Mapleshade Elementary School

Town of East Longmeadow ADA Transition Plan

October 2025

Institute for Human Centered Design

Figure 1: In the following image, the yellow lines show approximate routes to connect the softball and soccer/lacrosse fields, along with the team seating areas associated with each field, to the nearest accessible routes.

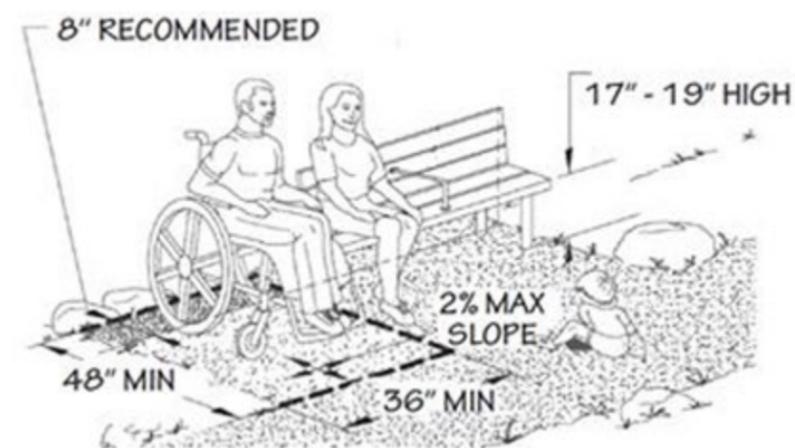
Accessibility issues include a lack of an accessible route to the softball and soccer/lacrosse fields.

Additional accessibility issues at the softball and soccer/lacrosse fields include lack of accessible spectator and team seating spaces.
